# ***Interactive comment on* “A multi-purpose, multi-rotor drone system for long range and high-altitude volcanic gas plume measurements” by Bo Galle et al.**

**Bo Galle et al.**

Received and published: 6 March 2021

**Fig. 1.** This is a new Fig.1. showing some flight log data

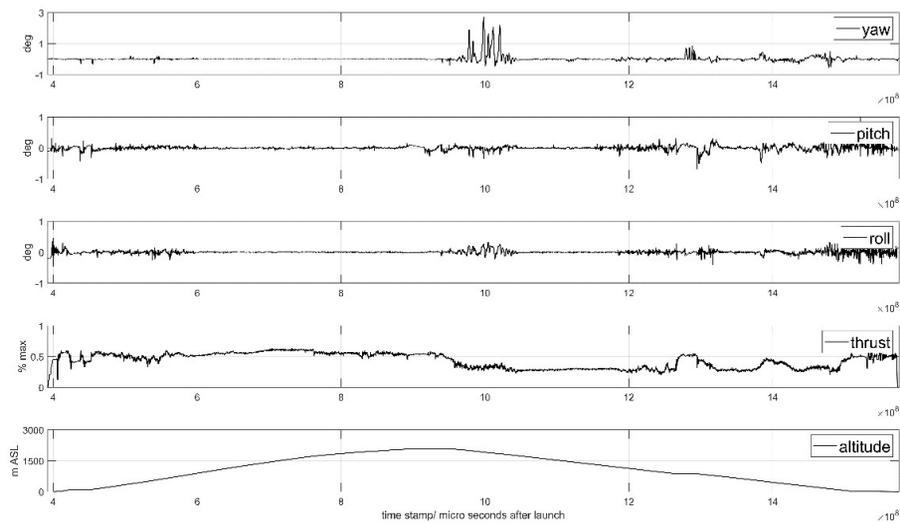
Reviewer: I.149-156: These seem like very important operational observations. However, critical details are left out or are too vague. “The drone’s angle. . .also proved to be of great important for energy consumption.” Can this be made more specific and

actionable? What is an optimal flight vector? Roughly how much endurance might the flight optimization gain? Why did power consumption go up so much when encountering clouds ?

Reviewer: I. 169-171: "Access to the drone flight logs were found to be useful. . ." I agree that they would be very useful for the reasons stated. Please make the logs available as part of the data release.

Response: The energy consumption probably goes up in clouds due to increased turbulence, forcing the drone to react. More on this is given on the new page 7 and new Fig 1. , attached as Fig 2 here with new caption "Flight data from the drone flight shown in Figure 9. The upper panels show time-series of yaw, pitch and roll angles, the thrust (percentage) and the altitude of the drone. Notice the high variability of the parameters associated with acceleration, hovering and interference from clouds."

Response: We think it is a bit too much to include the full flight logs for all the flights in

the data release. We have however included some flight log data for a typical flight in the new Fig.1. (attached here as Fig. 1.)

**Fig. 2.** This is the new Fig.2., replacing the earlier Fig.1.

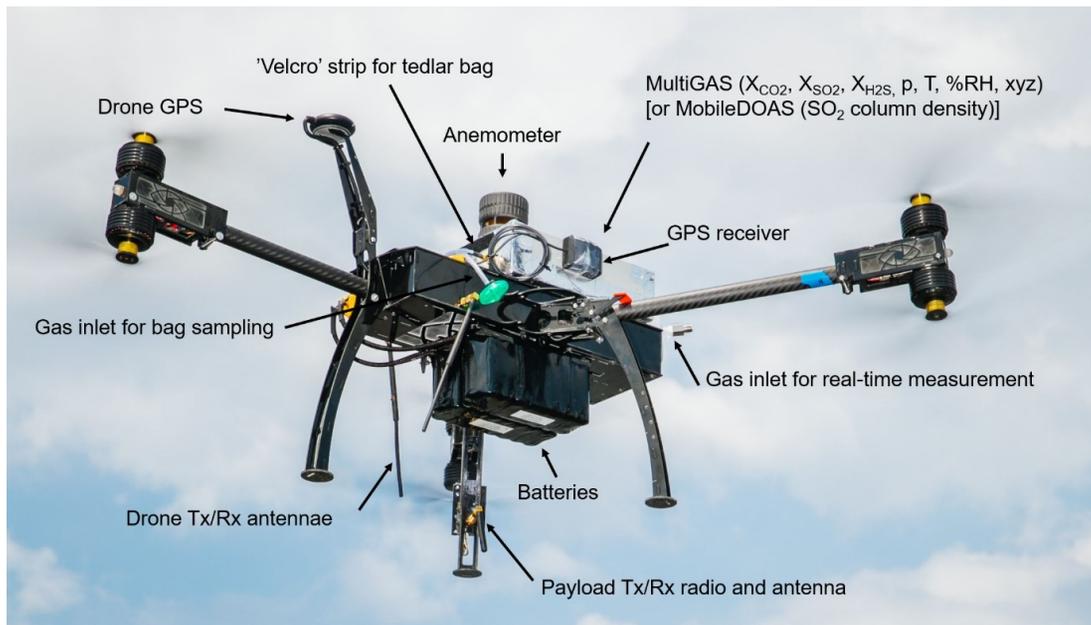
Reviewer: 2. Figure 1 of the manuscript is copied verbatim from Liu et al. (2020) supplement Figure S3b (shown below) and without correct attribution. Although the team for the two papers are much the same, ‘recycling’ figures in this way is poor practice and - at minimum - any previously published images and/or figures need to be cited properly.

Response: We have replaced the figure using a different background photograph and adding more details for the sensors and other instrumentation (New Figure 2, attached as Fig 2 here). Caption: "Photo of the multi-rotor drone with modular payloads. The MultiGAS unit includes in situ sensors for gas composition (XA-denotes concentration of species A, p-pressure, T, temperature, %RH-relative humidity, xyz-tilt coordinates), a gas-sampling unit and an anemometer. The MobileDOAS is used for remote sensing of gas flux. The modules are clamped to the drone at balanced position. The battery pack is placed below the drone chassis to lower the center of gravity of the system. Flight and sensor data are telemetered in real-time (photo courtesy of Matthew Wordell)".

**Fig. 3.** Figure illustrating closed loop gas-bag measurements, Fig S.1. in Supplement

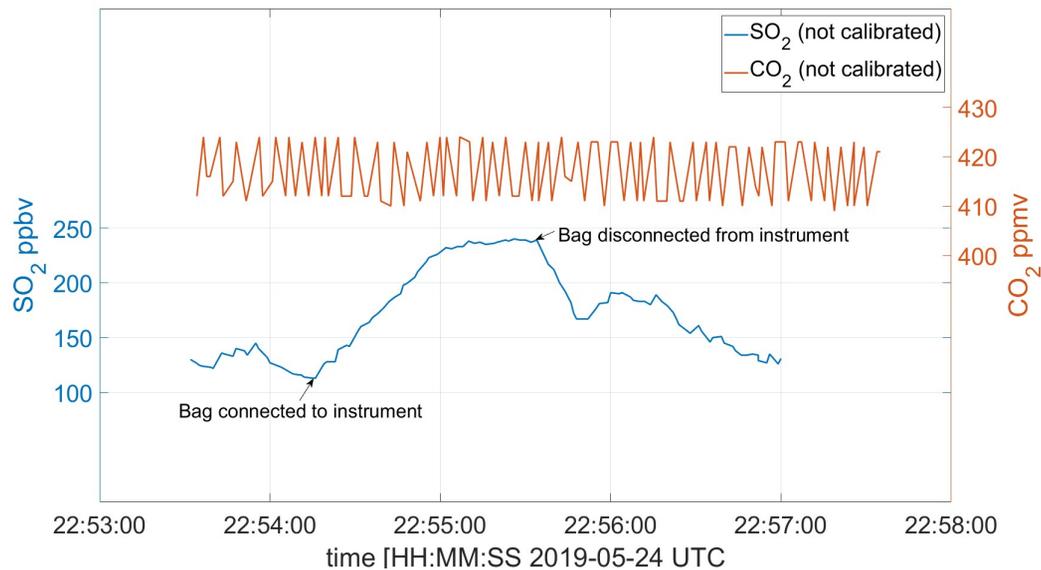
Reviewer: L.327-329: This is an interesting idea, but I do have concerns about its viability. Would a ~1L tedlar bag provide enough gas to get a good 'plateau value' from the sensors? How long do the sensors take to plateau during calibrations? Also, at low concentrations I would expect some sorption of S-containing species that could impact the results.

Response: We have added: "In this mode the gas from the teflon bag is circulated through the detectors in a closed loop and thereby exposing the detectors for the constant gas concentration in the sample for several minutes. Another advantage here is that any possible losses, i.e. wall effects, could be monitored and compensated for. This method was tested only once in the actual field campaign, because the limited gas samples was instead used for isotopic composition analyses." The only test made to practice the method used a sample that was too diluted for a successful measurement of CO<sub>2</sub>, but it probed that the closed-loop principle could work. The figure of the uncalibrated signals for this test is shown as Fig.3. here (measurement on 22 May 2019). As clearly shown, the SO<sub>2</sub> signal is detectable and its curve of growth stabilized in about 30 s (t<sub>90</sub>), which matches well with the manufacturer's specifications. But the signal, after calibration, is less than 1 ppm and therefore the CO<sub>2</sub> signal above background is below the detection limit of the instrument (remember the molar ratio for both species at Manam was found to be close to 1). The figure also shows a noise picked up by the CO<sub>2</sub> sensor, which we attribute to the radio. This signal is subtracted together with the background as part of the corrections. This information is included in the Supplement.
